Change title and text of 33.1.4 as follows:

33.1.4 Type 1 and Type 2 System parameters

Figure 33-13— $I_{Inrush-2P}$ current and timing limits, per pairset in POWER_UP

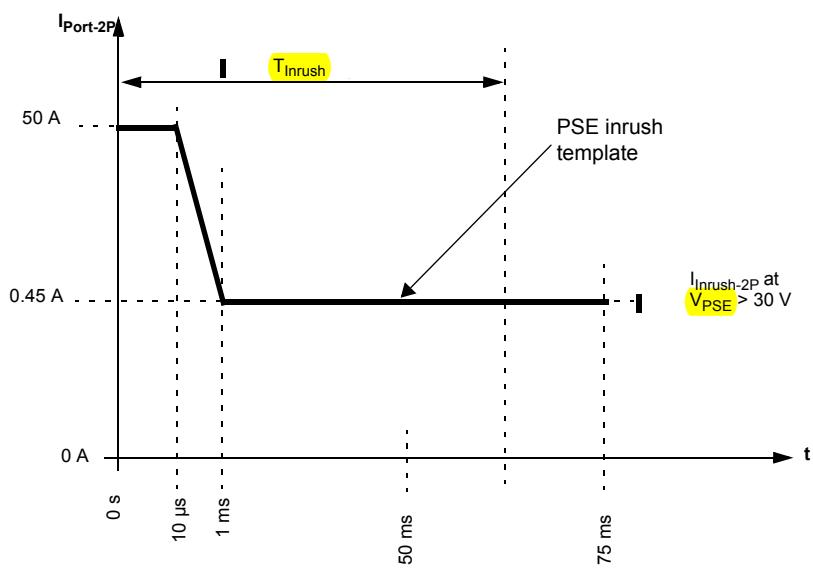
Replace Figure 33-13 with the following:

The PSE shall limit the maximum current sourced ~~at the PI per pairset~~ during POWER_UP. The maximum inrush current sourced by the PSE ~~per pairset~~ shall not exceed the ~~per pairset~~ PSE inrush template in Figure 33-13 and Equation (33-5).

Figure 33-14—POWER_ON state, per pairset operating current templates

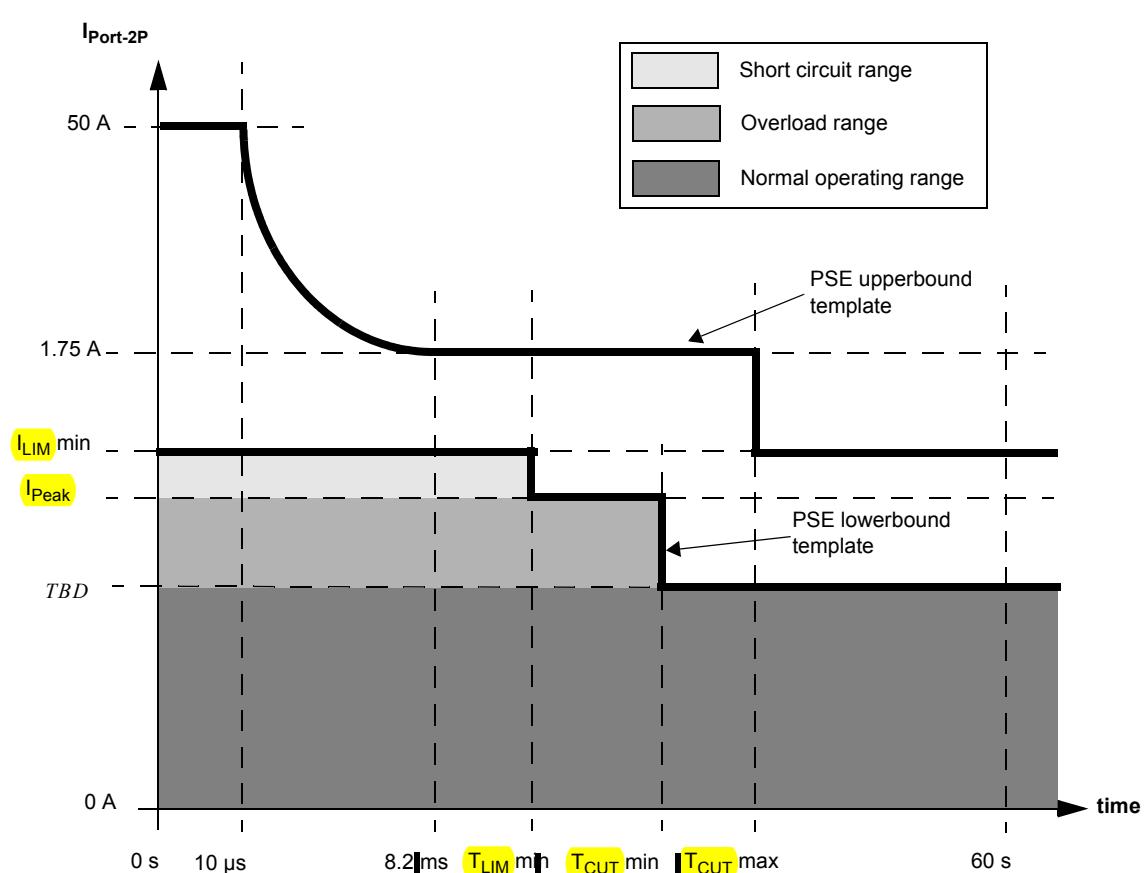
Replace Figure 33-14 with the following:

A PSE may remove power from the PI if the PI current meets or exceeds the “PSE lowerbound template” in Figure 33-14. Power shall be removed from the a pairset PI of a PSE before the pairset PI current exceeds the “PSE upperbound template” in Figure 33-14. When connected to a single signature PD, a Type 3 or Type 4 PSE should (TBD) remove power from both pairsets before the current exceeds the "PSE upperbound template" on either pairset.

Figure 33-18—PD static operating mask

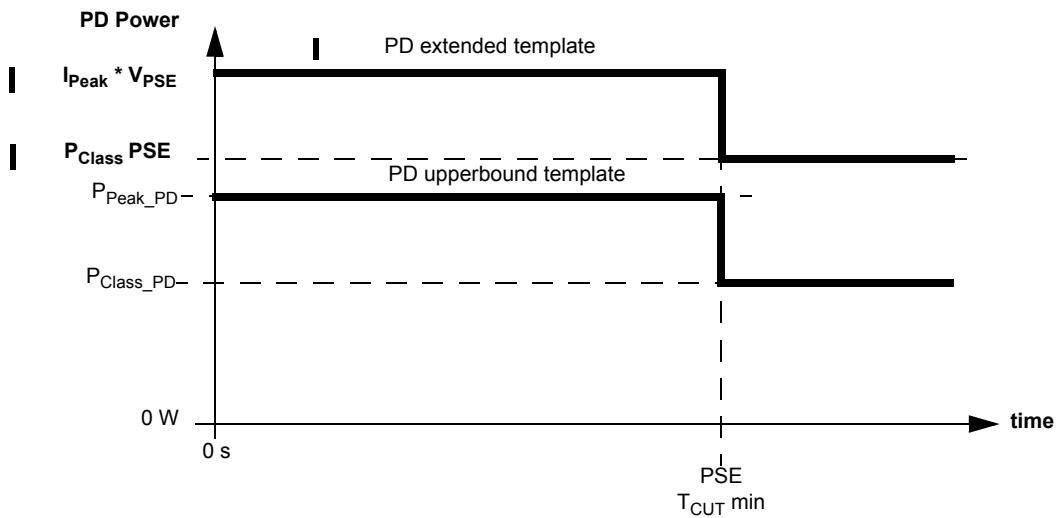
Replace Figure 33-18 with the following figure:
